# **PEX 8533**

**PCI Express Switch**

## **Silicon Revisions and Errata List**

**Version 1.7**

## **Erratum #10 – Dropped SKIP Ordered Set when Exiting L1 Power Management State**

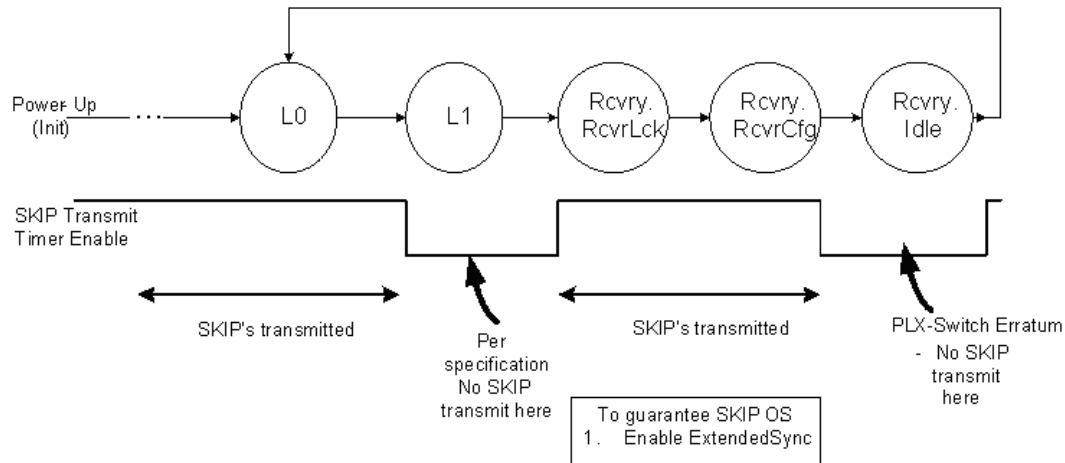
When exiting from the L1 Power Management (PM) state, there is a narrow window (recovery.idle state) during which no SKIPs are transmitted. The exit from L1 PM state steps through 3 sub-states – 1) rcvry.rcvrlock, 2) rcvry.rcvrconfig and 3) rcvry.idle. For the duration in which the link is in Recovery.idle state (waiting for receipt of 8 Idle

symbols) there will be no SKIP ordered sets transmitted. Note, SKIPs will be transmitted properly when entries into recovery sub-states are from another (L0 or L0s) state.

The Figure below illustrates the behavior.

Disable the PEX 8533 upstream port's entry to L1 state for ASPM L1 [78h[1:0]] and PCI PM (device specific offset 1E0[7]) mechanisms.
